Product Change Notification

Bourns® Trimpot® Product Line Announces 3269 Product Change

Current Material Compared to the Bromine-Free Material

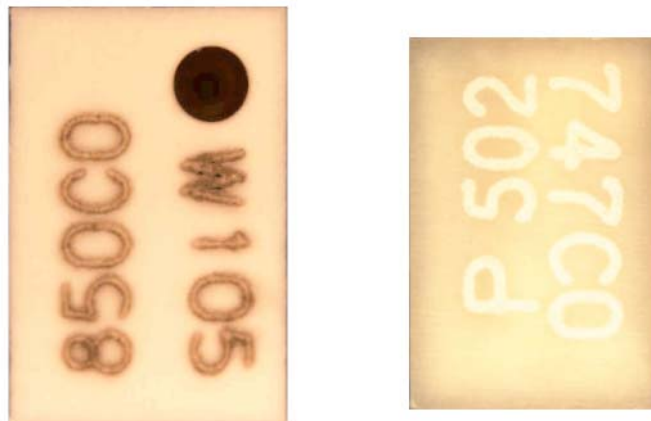
Bourns is pleased to announce a product change to [Model 3269](#). Effective March 2, 2009 with date code 910C we will begin phasing in a new bromine-free housing molding compound.

The laser marking on the new material has a different appearance than the current material. The new laser marking has a white appearance, unlike the old material, which has a dark brown appearance.
